4709 ROOSEVELT WAY NE

SDCI # 3038322-EG | MUP # 3036766-LU

EARLY DESIGN GUIDANCE MEETING #2

07.18.2022

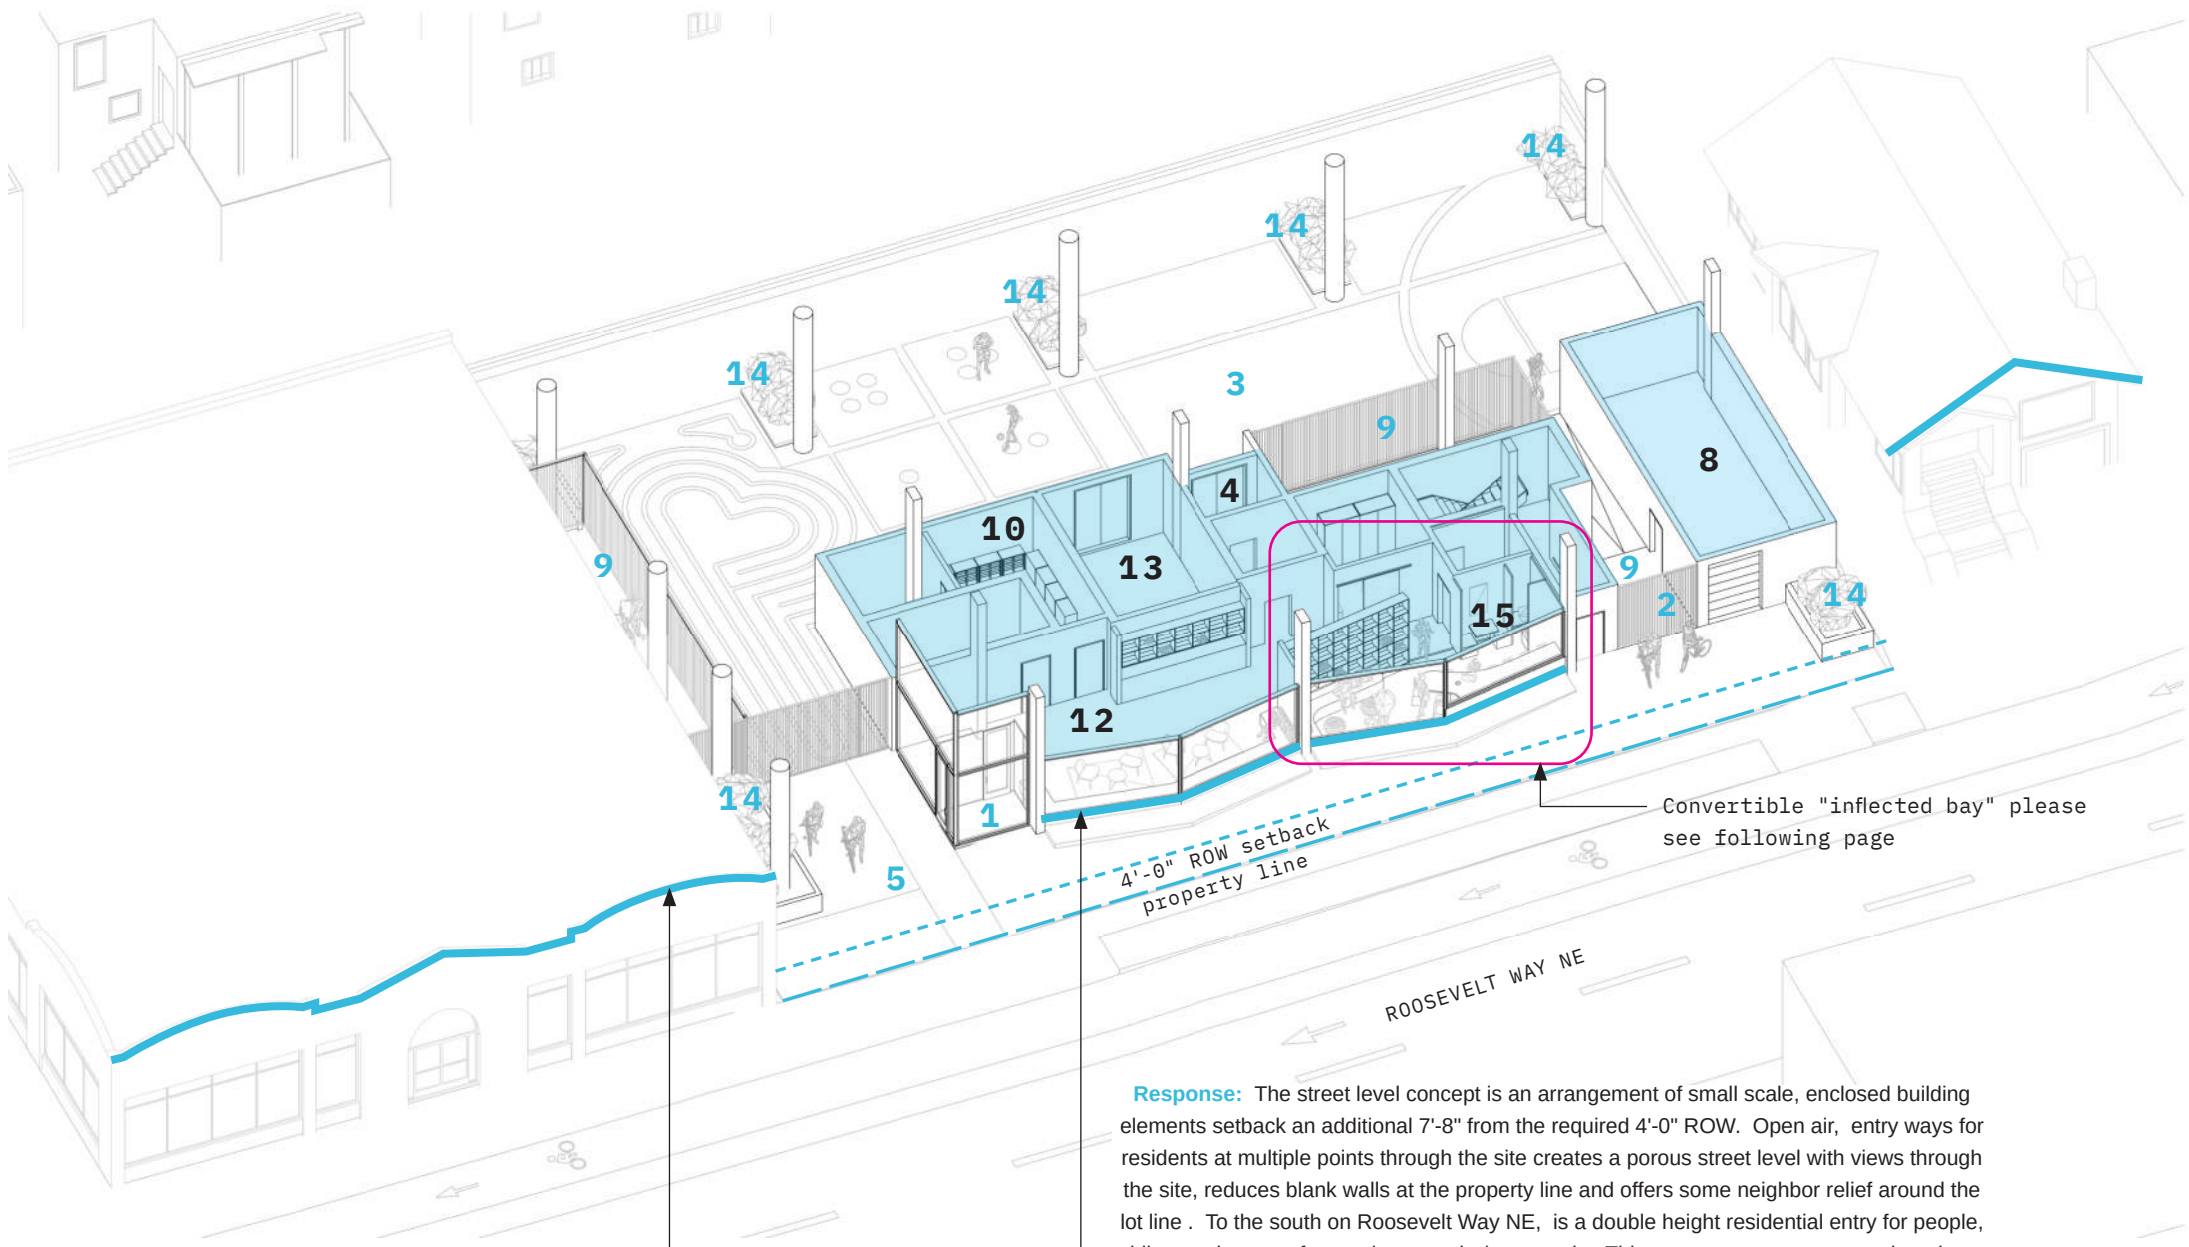
a. . . The Board requested the applicant provide opportunities to introduce a commercial space at the street level.

The Board was concerned the large amenity space at the street level would not activate the street and instead create a dead zone along the building's street frontage.

The Board requested the amenity space provide the flexibility to permit a future commercial space(s) to provide for street activation. The Board requested the applicant study the adaptability of the amenity space to convert to commercial spaces in the future. (DC1.A.3, University Supplemental Guidance PL3.3.f, PL3.3.d, PL3.3.e)

Response: The street level concept is an arrangement of small scale, enclosed building elements setback an additional 7'-8" from the required 4'-0" ROW. Open air, entry ways for residents at multiple points through the site creates a porous street level with views through the site, reduces blank walls at the property line and offers some neighbor relief around the lot line. To the south on Roosevelt Way NE, is a double height residential entry for people, bikes and access for on-site move-in / out needs. This space opens to a covered outdoor recreation area for residents. Two "inflected" bays modulate the street-scape and subtly reflect the parapets and rooftops of its neighbors. The bay to the south encloses residential leasing functions, while the adjacent bay to the north is intended to be a residential study that could be converted into an retail kiosk or pop-up style retail.

EDG 1 & EDG 2 - ROOF PLAN COMPARISON

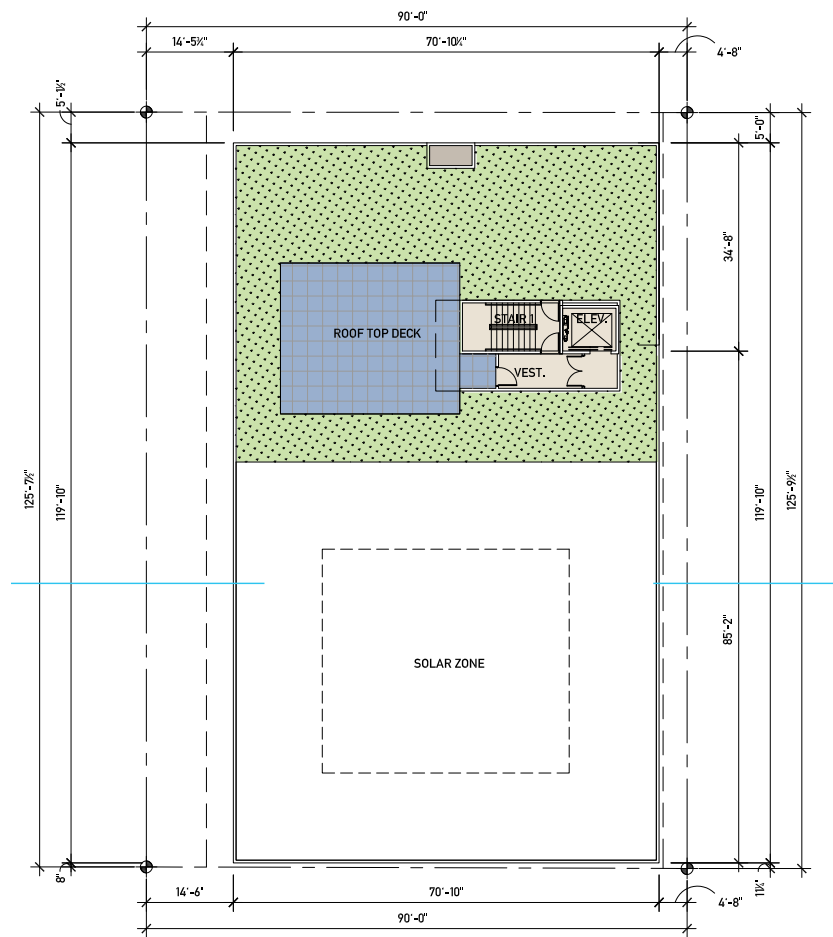
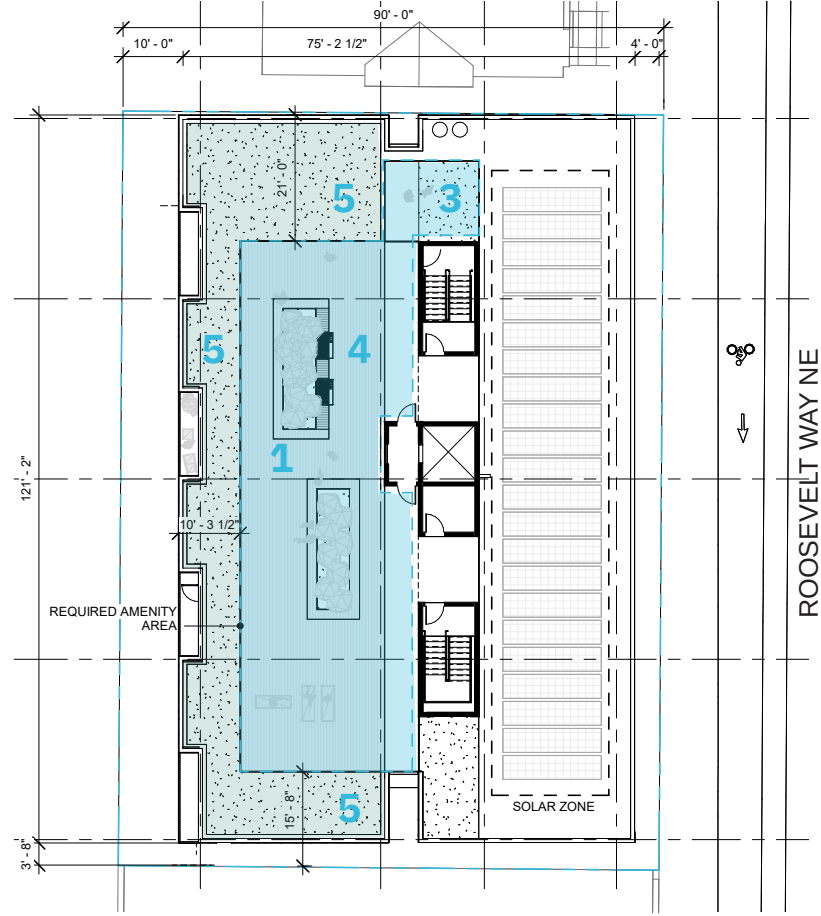
a. The Board requested the applicant provide a calculation of the required amenity area for the Board members to better understand what the required minimum amenity area for the project is. In addition to this information, the Board requested the applicant provide opportunities to introduce a commercial space at the street level. The Board was concerned the large amenity space at the street level would not activate the street and instead create a dead zone along the building's street frontage. The Board requested the amenity space provide the flexibility to permit a future commercial space(s) to provide for street activation. The Board requested the applicant study the adaptability of the amenity space to convert to commercial spaces in the future. **(DC1.A.3, University Supplemental Guidance PL3.3.f, PL3.3.d, PL3.3.e)**

Response: The amenity area required by zoning is proposed to be outdoors per SMC. 23.47A.024.B.2 "Amenity areas shall not be enclosed." The unenclosed amenity area is located on the rooftop terrace. By removing the amenity area from the street level, the ability to consider future retail uses is proposed. **(Please see the flowing page for residential amenity area calculations and SDCI Gross Floor Area diagrams & pp 78-81 for street level information.)**

EDG 2 - LANDSCAPE CONCEPTUAL SKETCH - ROOF

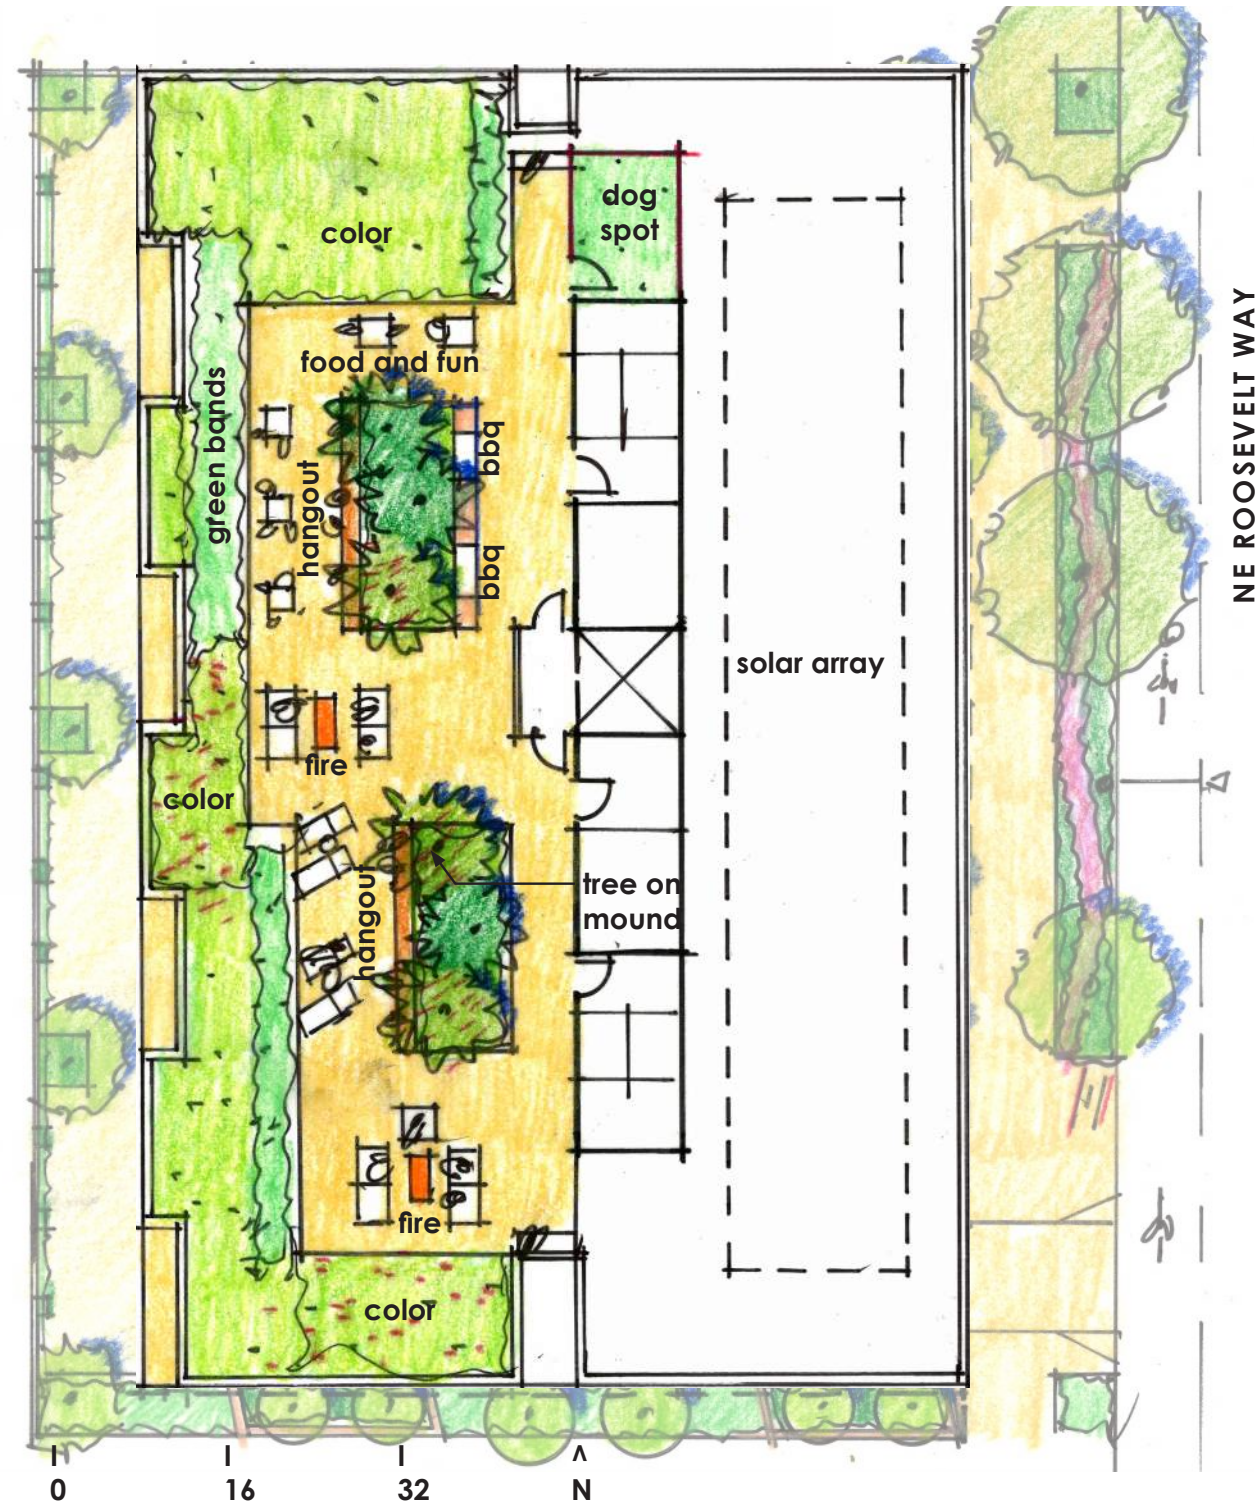
a. The Board requested the applicant provide a calculation of the required amenity area for the Board members to better understand what the required minimum amenity area for the project is. In addition to this information, the Board requested the applicant provide opportunities to introduce a commercial space at the street level.

The Board was concerned the large amenity space at the street level would not activate the street and instead create a dead zone along the building's street frontage.

The Board requested the amenity space provide the flexibility to permit a future commercial space(s) to provide for street activation. The Board requested the applicant study the adaptability of the amenity space to convert to commercial spaces in the future. (DC1.A.3, University Supplemental Guidance PL3.3.f, PL3.3.d, PL3.3.e)

Response: Amenity area calculations and area diagrams provided. All required amenity area to be outdoors per SMC 23.47A.024
